On 802.1Qcr D0.0

Johannes Specht, University of Duisburg-Essen

Purpose of this Slide Set

Example of an imprecise Implementation

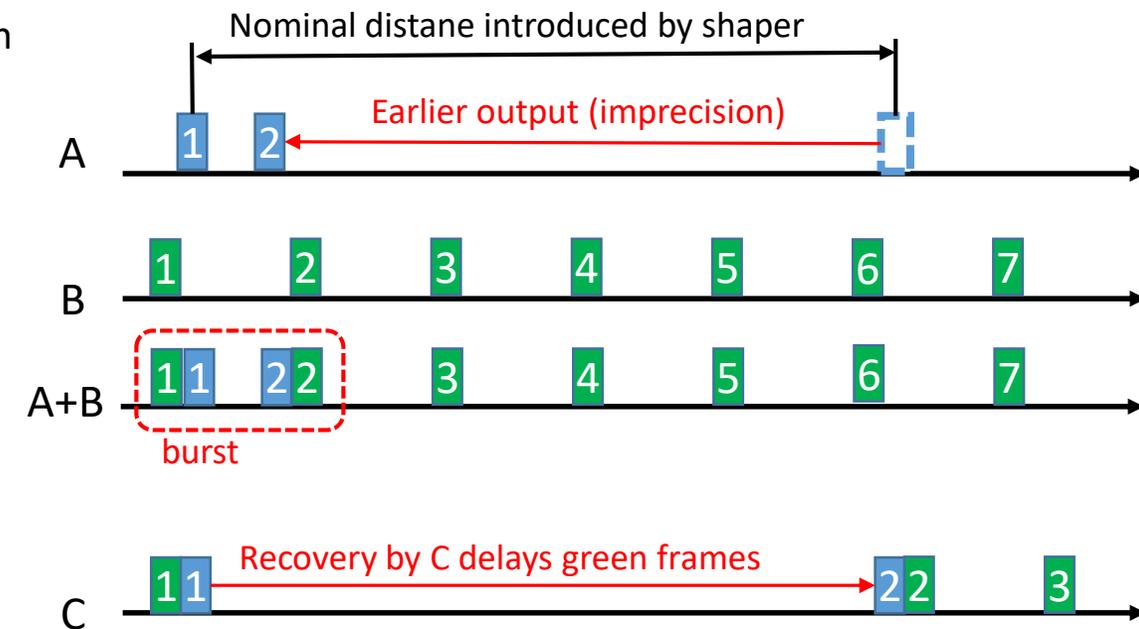
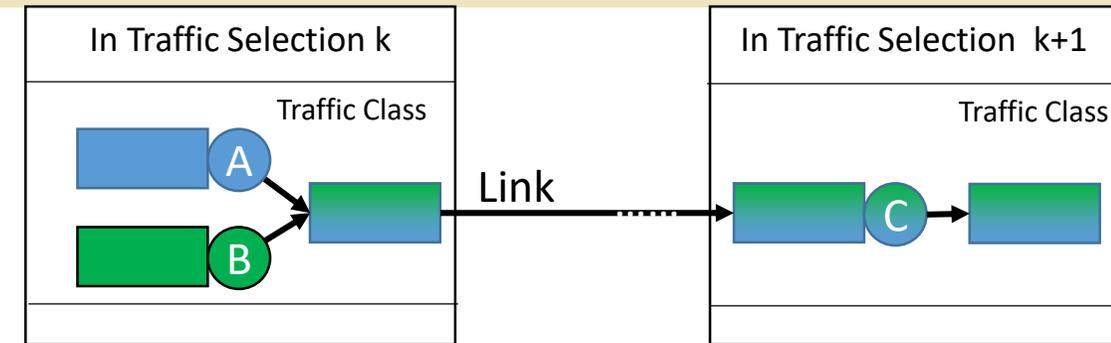
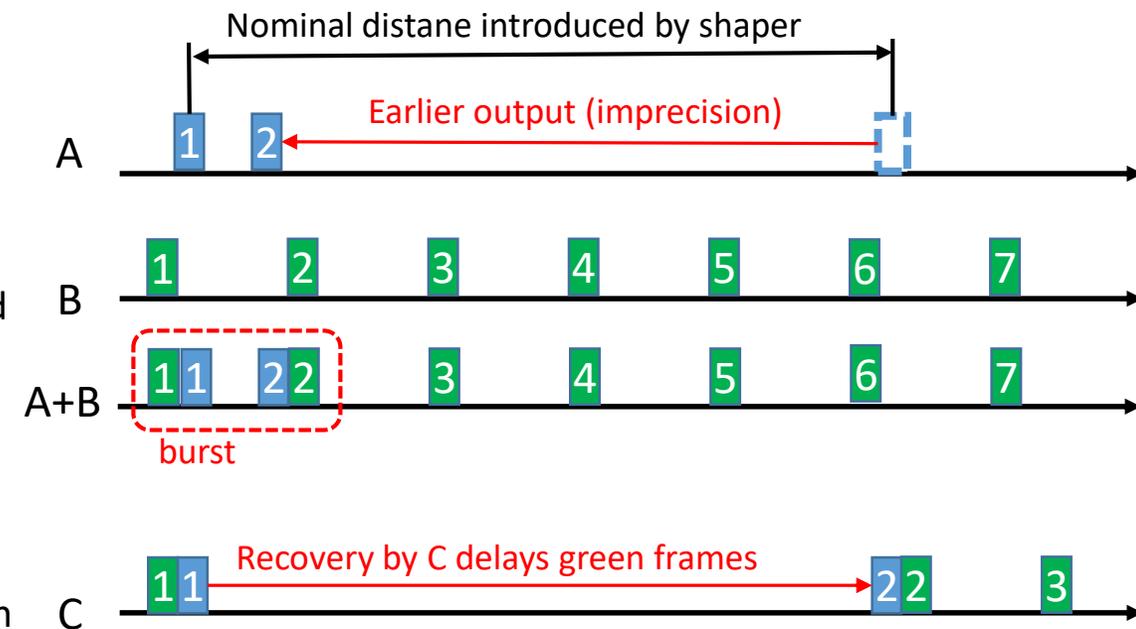
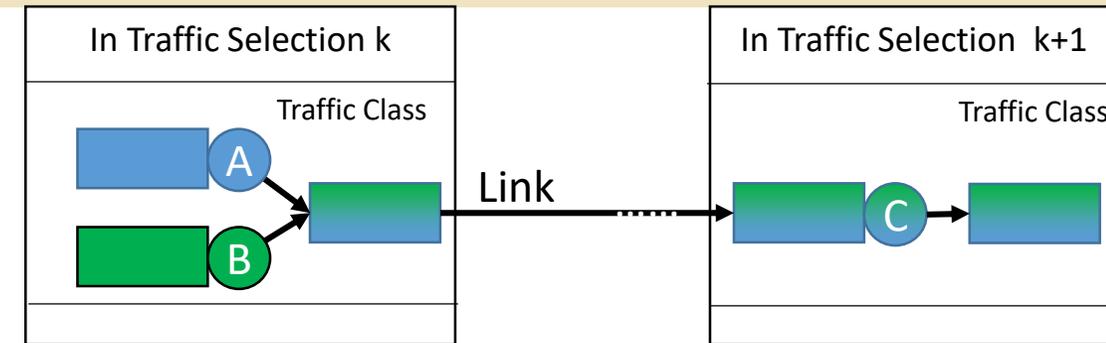
- Two-level queuing
(cmp. <http://www.ieee802.org/1/files/public/docs2015/new-tsn-specht-ubs-queues-0521-v0.pdf>)
 - Shaped queues (Nx per traffic class)
 - Unshaped queue per traffic class collecting the output from the shaped queues (1x per traffic class)
- Shaped Queues
 - A: *One* shaper state machine for **blue** streams, affected by imprecision
 - B: *One* shaper state machine for **green** streams, not affected by imprecision
 - C: *Two* shaper state machines, one for **blue** and one for **green** streams, not affected by imprecision

1. Frame #2 (**blue**) output happens earlier due to imprecision.
2. The *burst* in the unshaped queue (A+B) is larger than nominal.
→ **All lower priority traffic classes (not explicitly shown), including ATS classes, will experience a larger delay, because it takes longer until the unshaped queue drained.**
3. At C, the shaper state machine of **blue** streams recovers the nominal distance between frames #1 and #2.
→ **Green frames are shifted/experience unexpected large delays.**

- The shown effect is non-accumulative, as long as shaped queues output frames with some jitter. I.e., this jitter would not prevent bounded delays, but the impact can get large if shaper state machines are implemented in a naïve manner.
- In contrast, if a shaped queue would output permanently too fast (\gg committed information rate), calculating bounded delays gets hard to impossible. This comes to no surprise: If, for example, the shaper state machine belonging to A would output blue frames with 10 Mbit/s, AND the shaper state machine belonging to C would output blue frames with 5 Mbit/s, the result would be equal to a broken network configuration.
- Nonetheless, the author is unsure whether a set of well-defined imprecision parameters that fits all potential implementations can be found easily.

- Specify the shaper state machine algorithm more explicit, closer to implementation, and for which the author believes the negative impact on delay bounds is low.
- Derive imprecision parameters referring to this algorithm

Closing ATS Gates

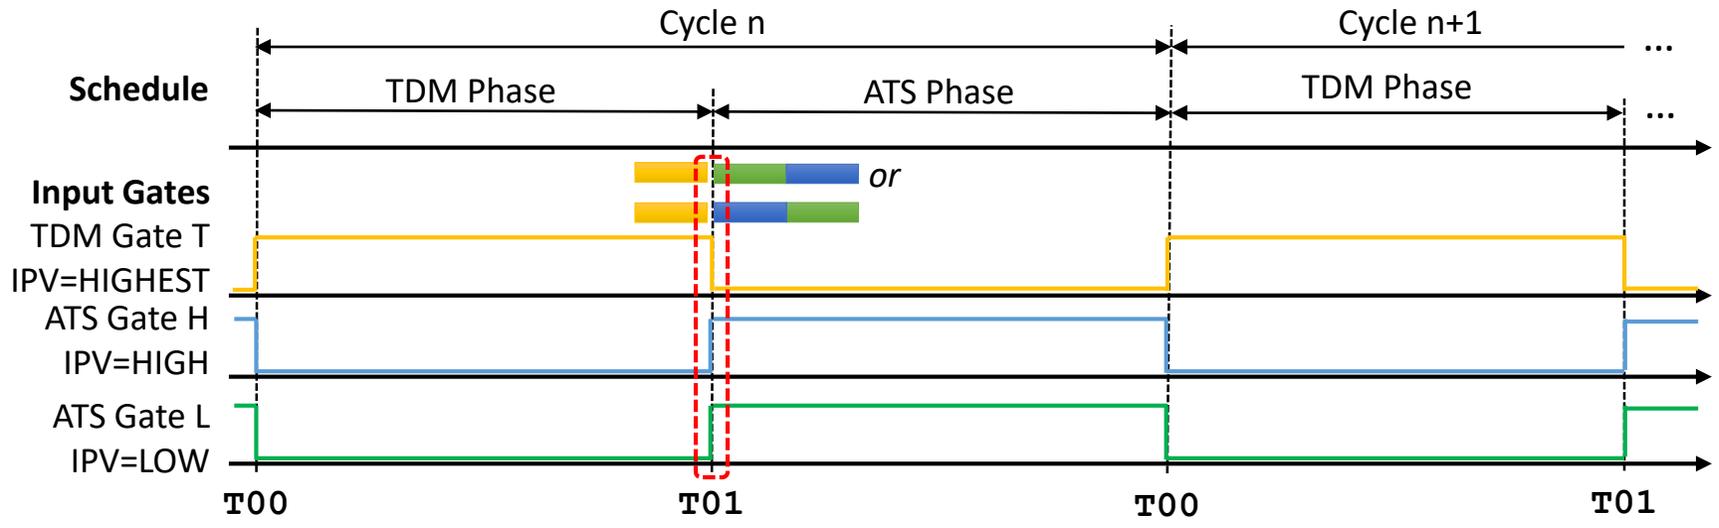
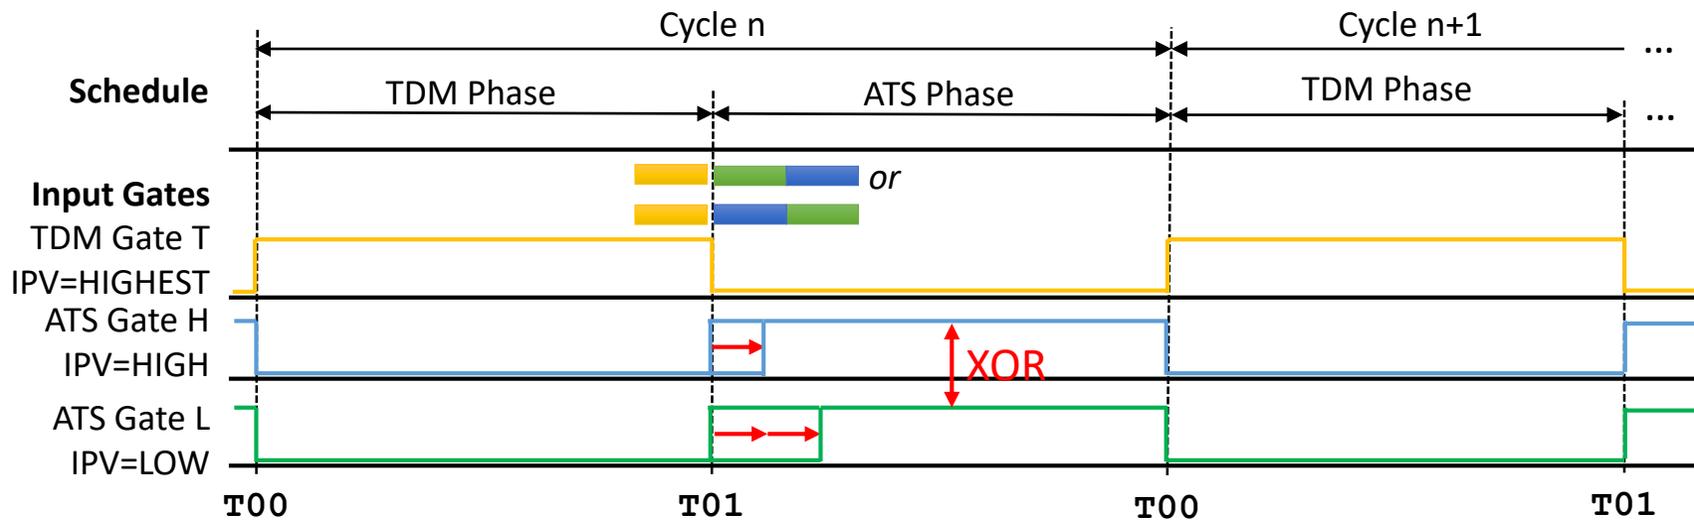
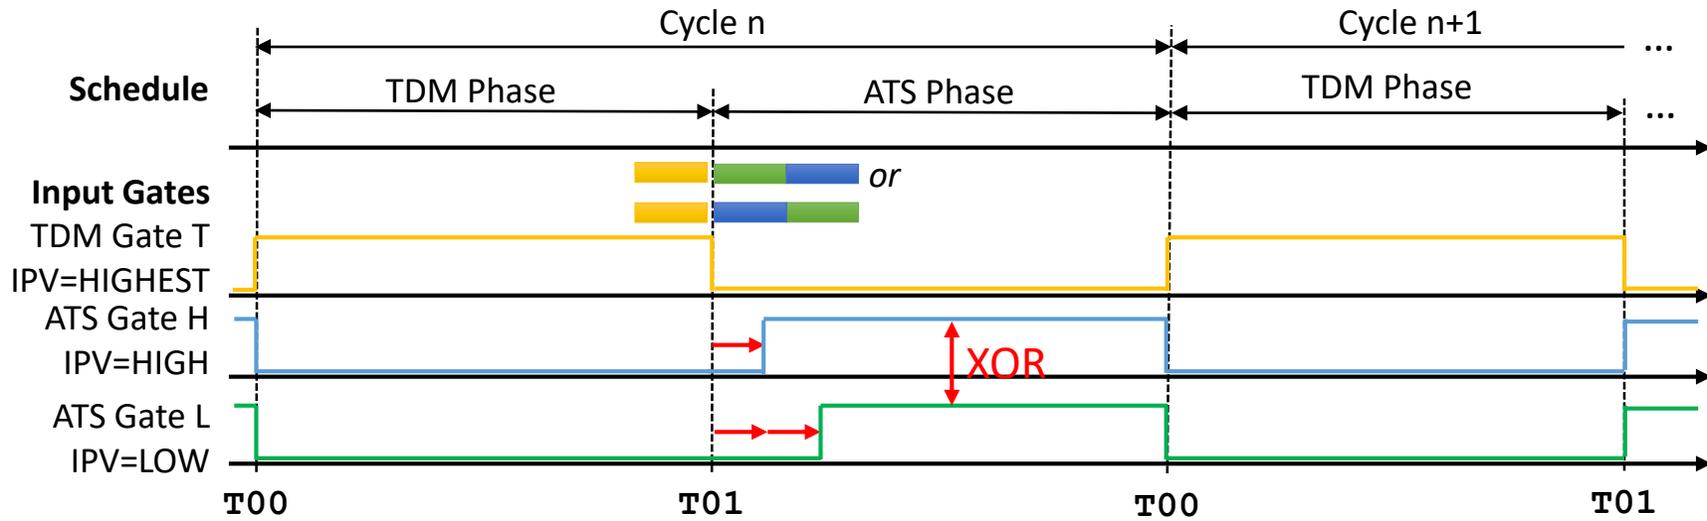
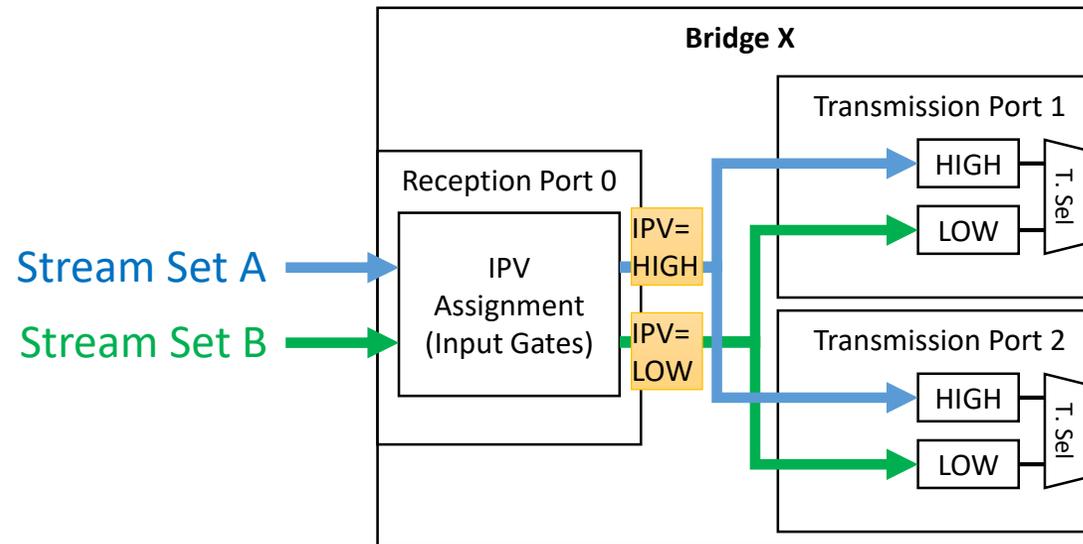
- In D0.0, ATS uses Input Gates for Transmission Priority Level Assignments via IPV: Each IPV requires a dedicated Input Gate
- Example of a mixed TDM and ATS setup with TDM and ATS phases:
 - HIGHEST priority level: Strict Priority Transmission Selection (TDM)
 - HIGH and LOW priority level: ATS Transmission Selection (2 Traffic Classes)
- ATS is Asynchronous:
 - The first ATS frame in an ATS phase is either IPV=HIGH or IPV=LOW, but this cannot be pre-determined
 - Two Input Gates (H and L) must be opened (or closed) in ATS phases simultaneously, while simultaneously Gate T is closed (or opened)
- Important:** Input Gates, as specified in 802.1Qci, allow this!
 Each gate has a separate control list, multiple control lists can contain events at the same times **However ...**

- Implementations may exploit the fact that, in a pure TDM setup with multiple Traffic Classes (no ATS), only a very limited number of Input Gates is opened simultaneously
- Example 1
 - 1 Input Gate is open at a time, all other Input Gates are closed
 - Gate ID can be encoded in $\log_2(\text{Max. Gate ID})$ Bits
 - **Problem:** Impossible to have several (2 in the example) simultaneously opened gates
- Example 2
 - Explicit open and close events for a single gate, but no simultaneous open and close events
 - **Problem:** Event processing will take some time (d) - no simultaneous gate transitions.
 → false positives, false negative, both

- This issue is implementation specific, as said - the Input Gate model in the standard seems ok to the author!
- However, is it nonetheless considered reasonable to address it?
- If Yes, there could be (at least) two Options:
 - **Option #1**
 Insert normative content in clause 8.6.5.2 (ATS), which ensures that, if multiple Gate Control Lists contain events with identical associated times, then all these events become effective simultaneously.
 - **Option #2**
 The proposed solution for Issue Z.2 (read on...)

The Issue

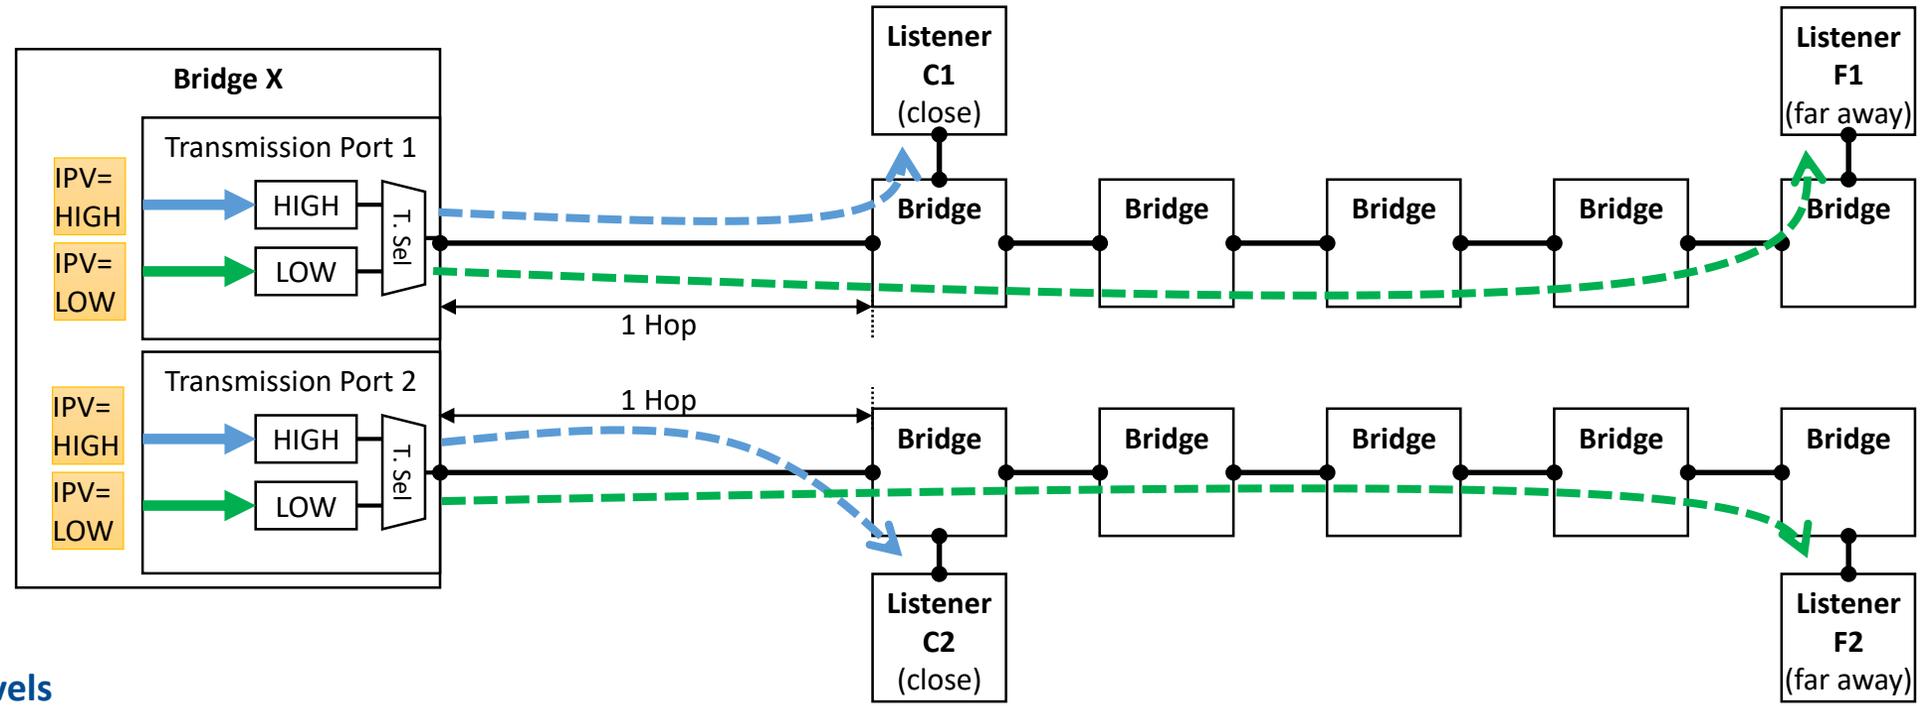
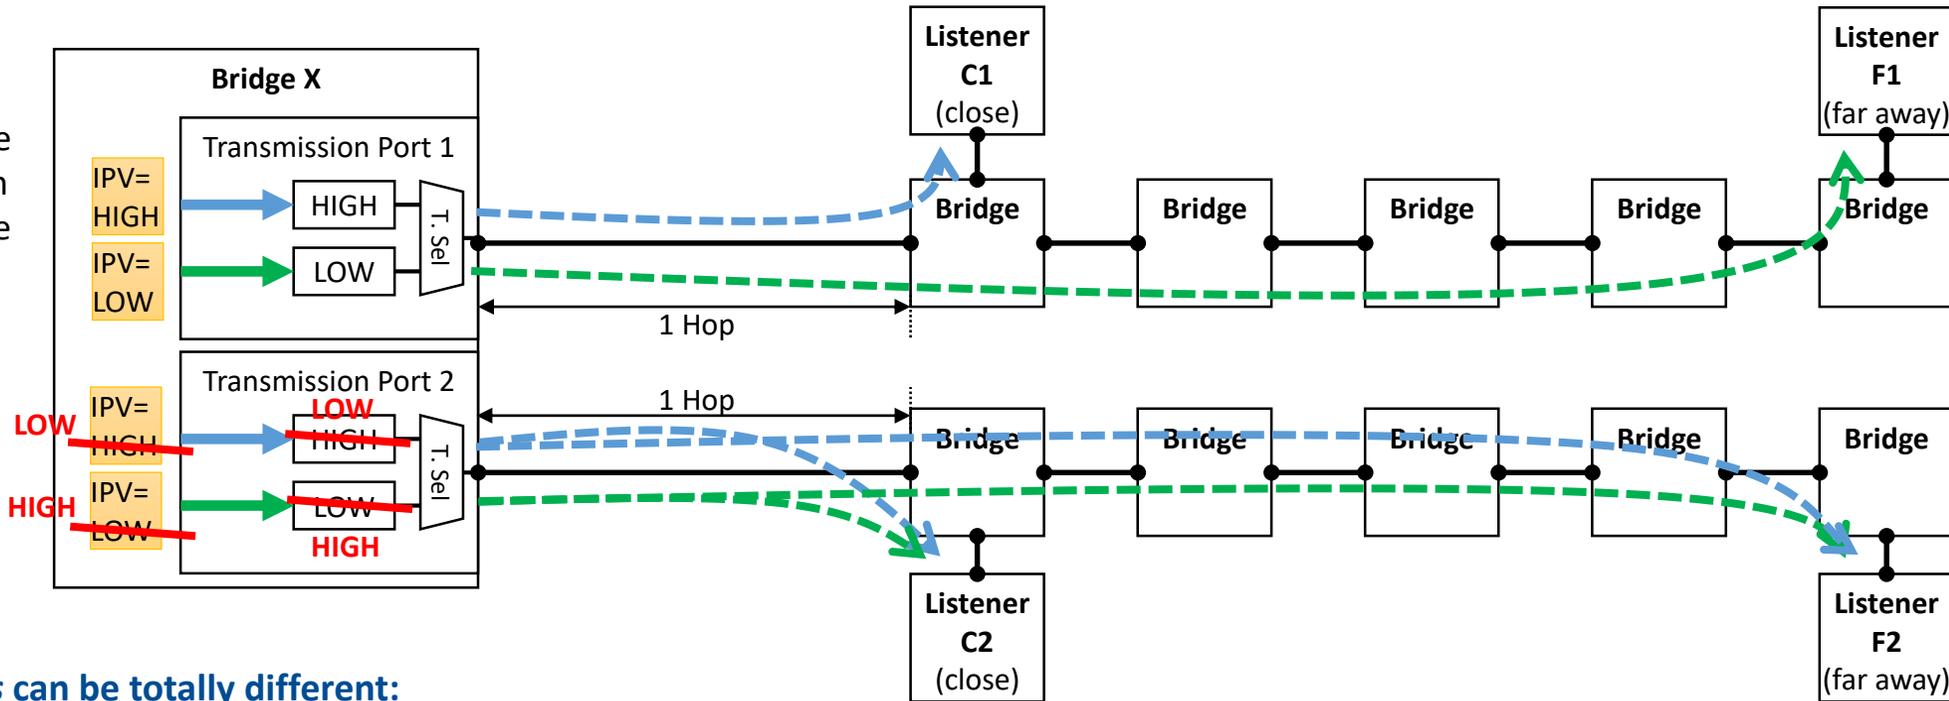
- Stream Set A: ~~12.0 μ s~~ 27.7 μ s
- Stream Set B: ~~27.7 μ s~~ 12.0 μ s

- In the shown example, Stream Sets A and B exchanged their Paths at Port 2
- Now, it makes more sense to send Set A with LOW priority and Set B with HIGH priority, but only at Port 2
- This would require two different IPV's to be assigned: One for Port 1 and another one for Port 2
- Note: The author believes that this is issue is not limited to ATS and affects other traffic types as well.

Meters vs. Shapers

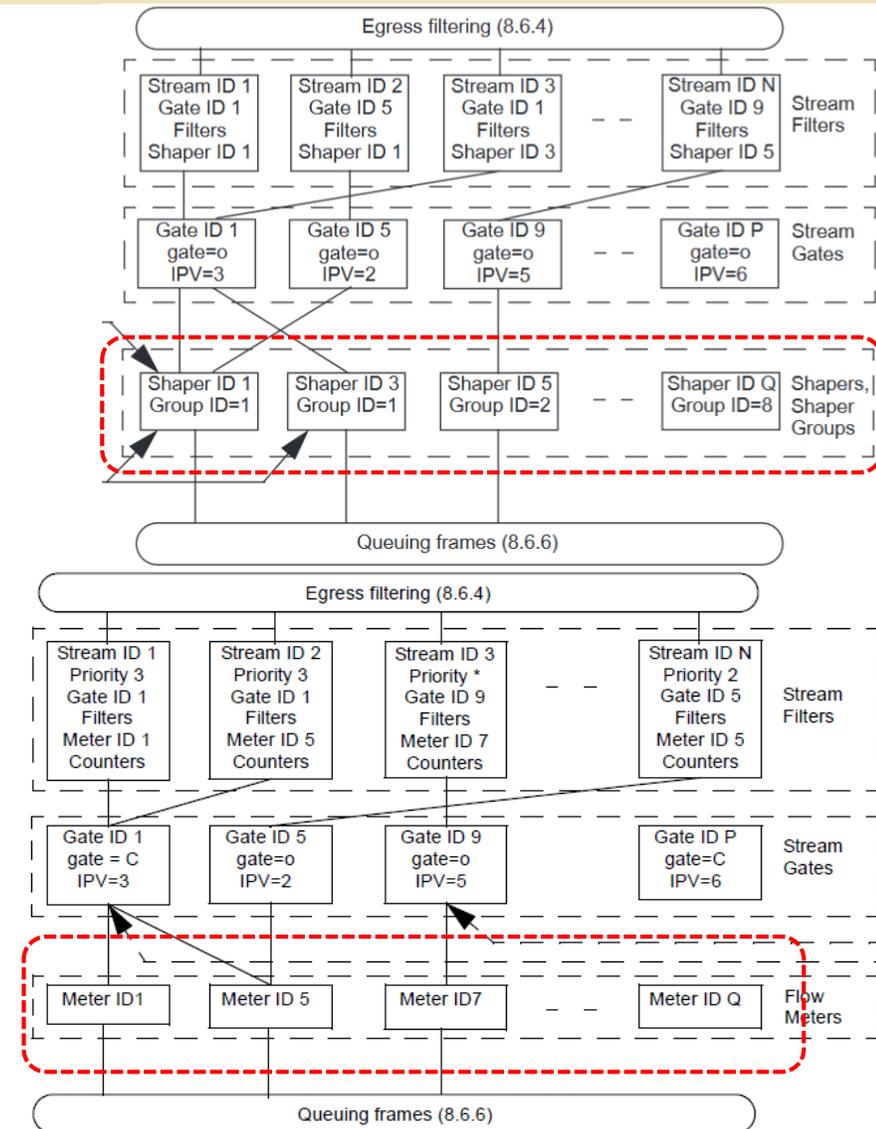
- Can Meters and Shapers co-exist?
- I.e., shall it be possible to process frames by Meters, followed by processing by Shaper State Machines?

- Shaping can be considered as a stronger form of Metering:
 - Meters drop frames that violate the configured traffic envelope
 - Shapers would introduce delays to comply with the configured traffic envelope.
- Co-existence would allow to, for example, meter subsets streams that are processed by one Shaper. If co-existence is not desired, then this is not possible.

- Unless decided differently by the TSN group, it remains inaccurate with a tendency against co-existence. The author can change this during the course of the project, but would appreciate presentations about use-cases for co-existing Meters and Shapers.
